**Re: Section 16 Planning Application for Temporary Open Storage of Containers and Vehicle Repair Workshop with Ancillary Facilities and Associated Filling of Land and Pond for a Period of 3 Years at Lot Nos. 340 RP (Part), 341 RP (Part), 342 RP (Part), 343 RP, 344 (Part) in D.D. 87 and adjoining Government Land, Kong Nga Po, Sheung Shui, New Territories**

## Further Information

## Summary of Comments and Responses

**Drainage Proposal**

Figure 3

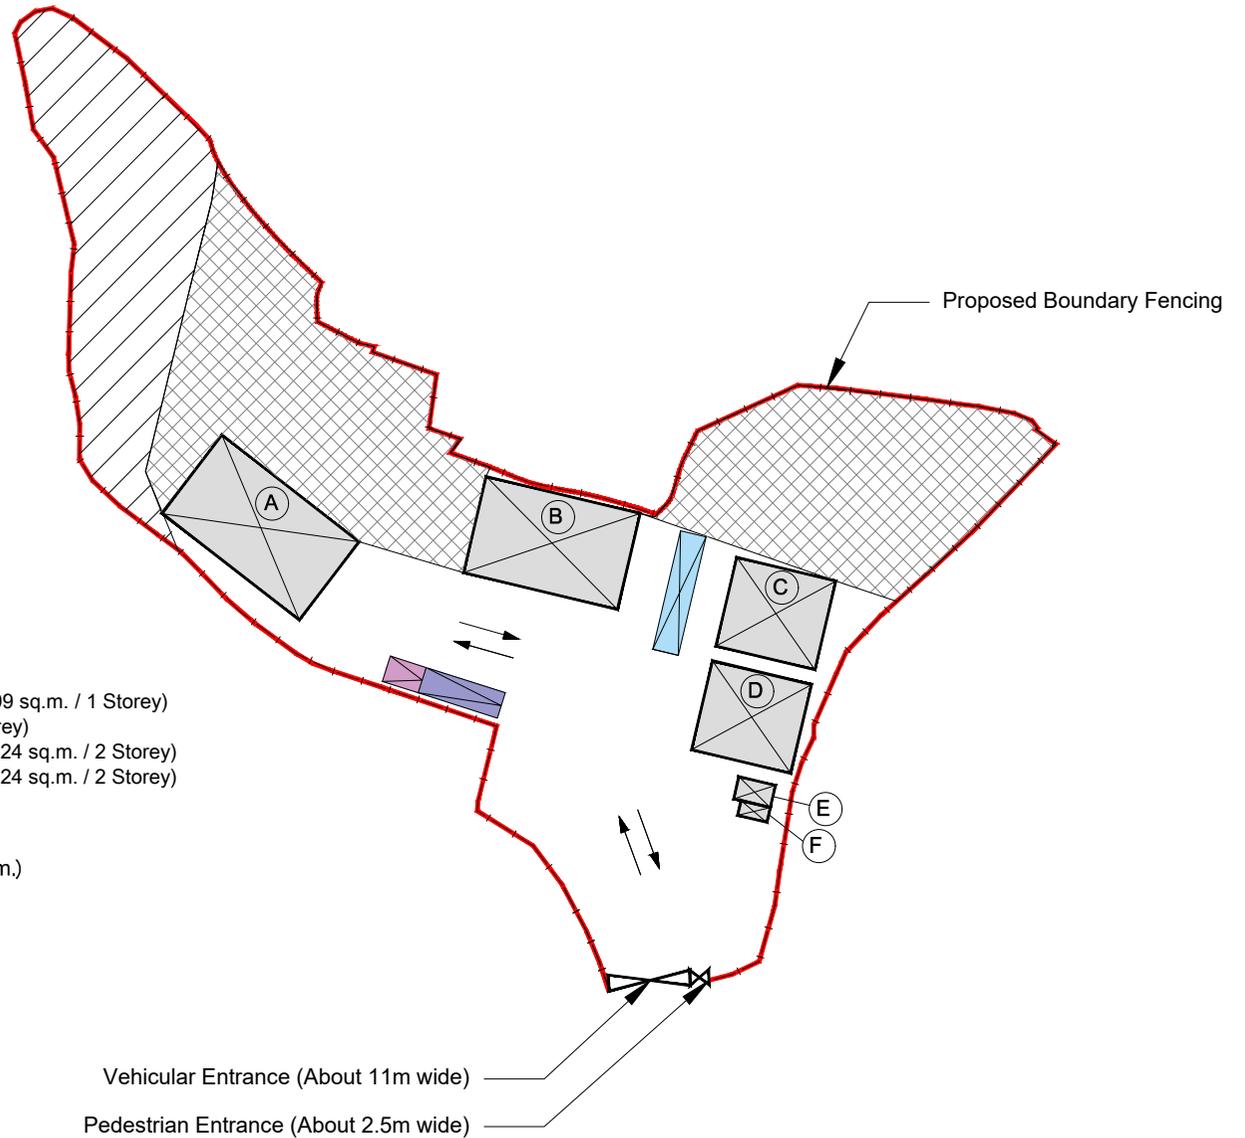
Department	Date	Comments	Responses to Departmental Comments
Transport Department	12.2.2026	<p>1. The applicant shall justify the adequacy of the parking spaces and loading/unloading spaces so provided by relating to the number of vehicles visiting the application site (the Site).</p>	<p>The internal transport facilities to be provided in the project site include one parking space for private cars, one for heavy goods vehicles (HGVs), and one L/UL space. As there are no specific parking and loading/unloading requirements for temporary open storage development in accordance with HKPSG, ancillary transport facilities are provided based on the Applicant's requirements to meet operational needs.</p> <p>Based on the planning application, the proposed development will generate about 1 to 2 vehicles per day. Therefore, the proposed parking spaces and L/UL spaces are considered adequate.</p>
		<p>2. The applicant shall demonstrate the satisfactory maneuvering of the vehicles entering and exiting the subject site, maneuvering within the Site and into/out of the parking and loading/unloading spaces, preferably using the swept path analysis;</p>	<p>Swept path analysis is conducted for the 11m-wide ingress/egress point, internal manoeuvring space, and the loading/unloading spaces. <b>Figure SP-01, Figure SP-02, and Figure SP-03</b> demonstrate that the ingress/egress point and parking space arrangement are adequate for manoeuvring 11m HGVs and 5m Private Cars, respectively (Please refer to <b>Enclosure 4</b>).</p>

4.5 Flow Path Comparison

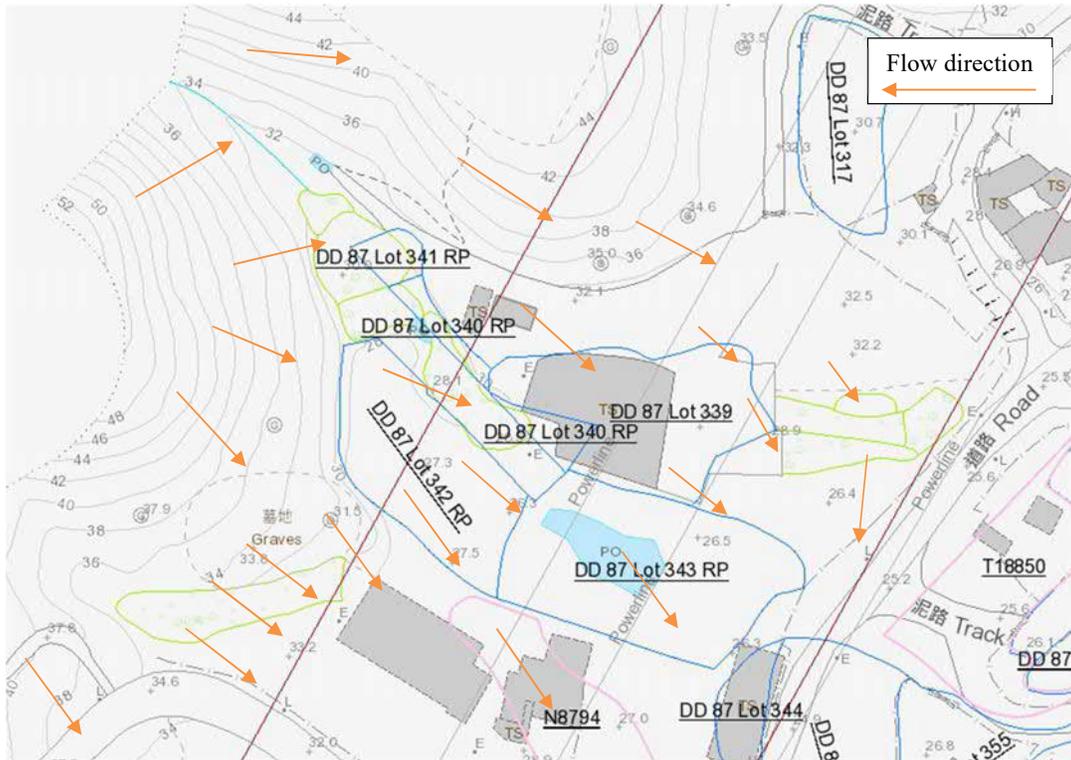
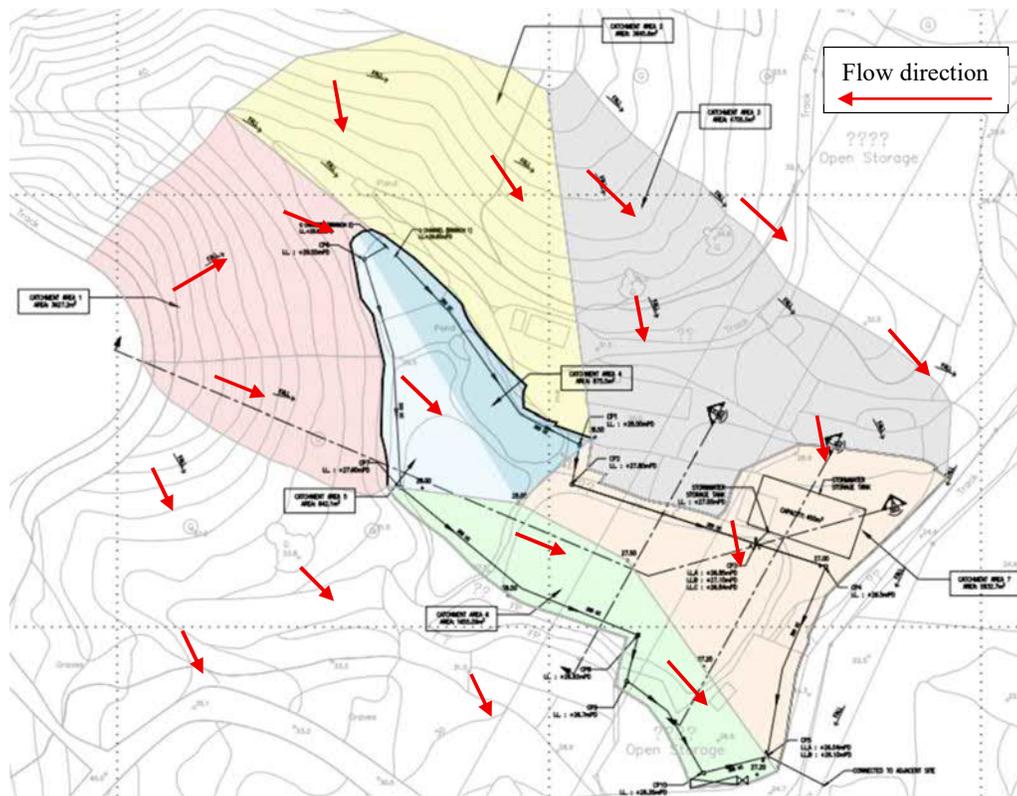
3.	For clarity, please provide the flow path comparison before and after the development for reference.	Please refer to Section 4.5 of the proposal for the flow path comparison. Since the development did not change the surrounding terrain. The flow path is basically unchanged.

DRAWING NO: WNG/24227/C/DRA/001

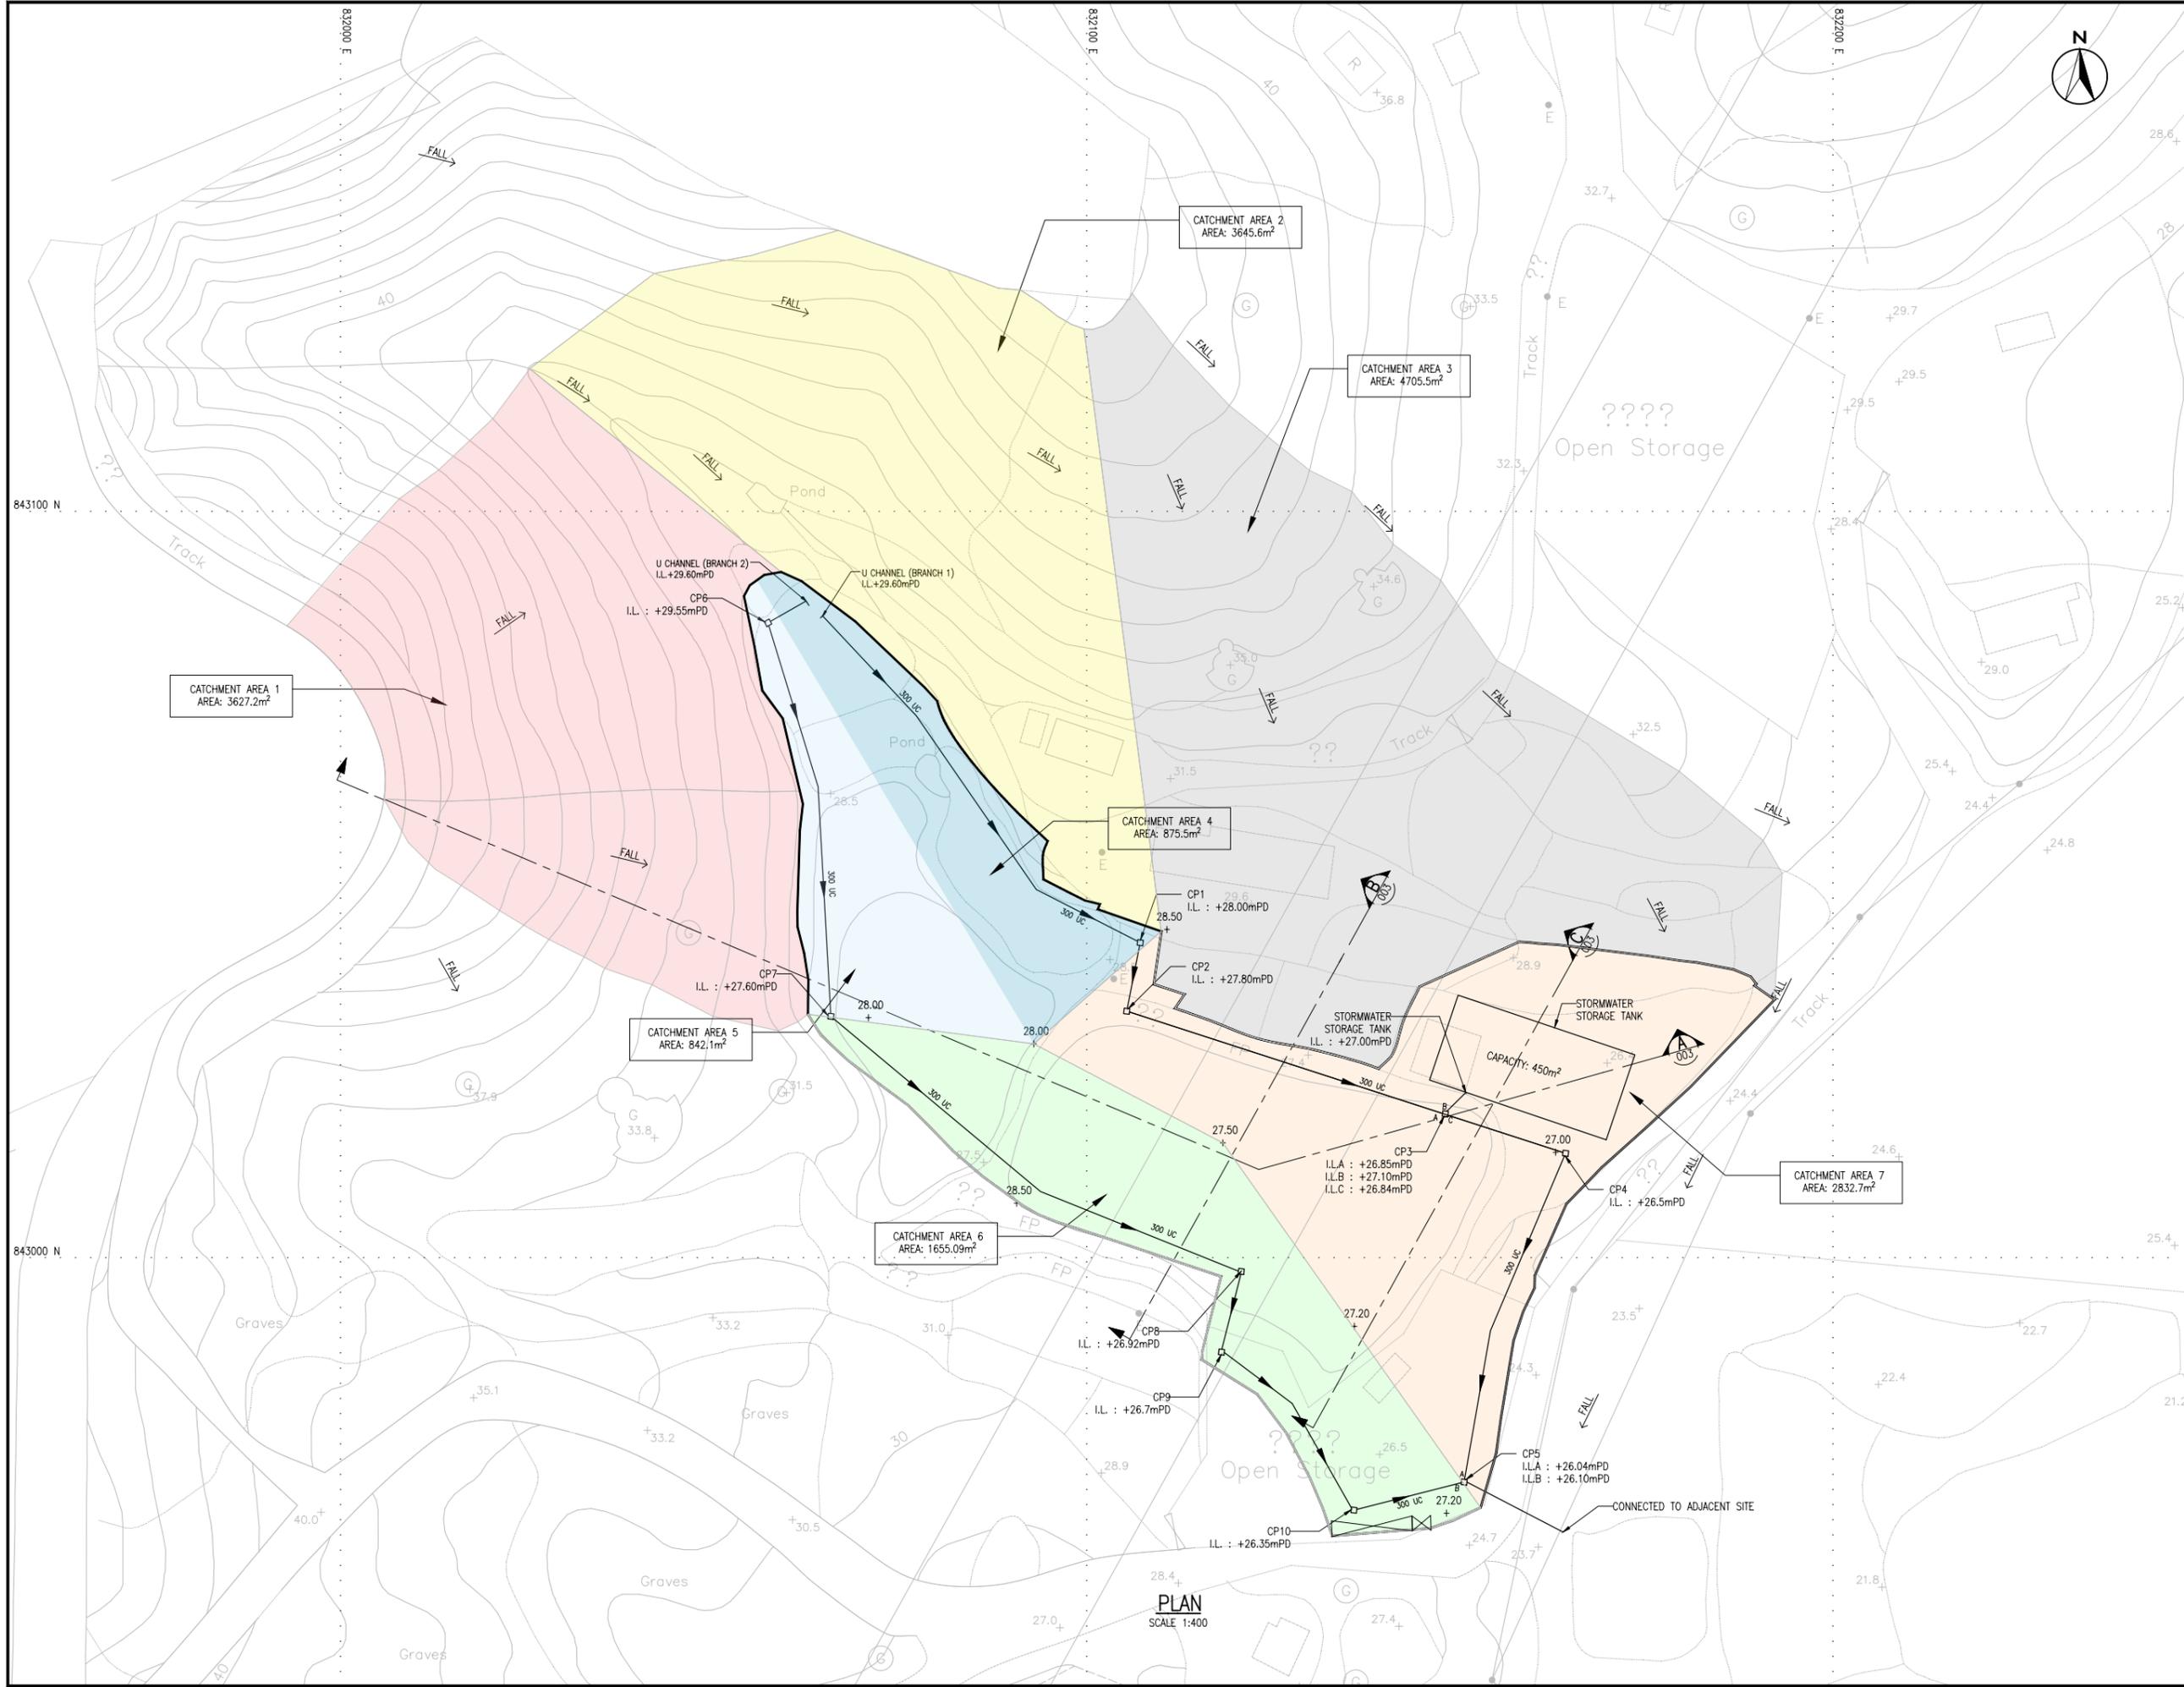
Item and reference	Comments	Wing's Response
1.	For Section 5.1 and Drawing Nos. WNG/24227/C/DRA/001. Please advise the final drainage discharge point and further drainage downstream, as the flow path cannot be identified. The applicant should check and ensure that the existing drainage downstream to which the proposed connection will be made has adequate capacity and satisfactory condition to cater for the additional discharge from the captioned site. He should also ensure that the flow from this site will not overload the existing drainage system.	The additional discharge from the development is proposed to be directed to the adjacent Lot 361RP. The drainage impact on downstream areas was assessed using InfoWorks and the result indicate there are little to no effect to the downstream capacity. The details result can be found in Appendix E.

2.	For Section 3.2 and Drawing Nos. WNG/24227/C/DRA/001. Please clarify if the drainage system within the site will be connected to the new pond. The flow path indicated on the drawing is not aligned with the statement.	The new pond in the previous submission will be reconstructed as a stormwater storage tank in this submission. Excessive stormwater will flow into the tank thereby temporarily storing incoming peak flows. Serving as a measure to reduce the peak discharge to downstream areas.
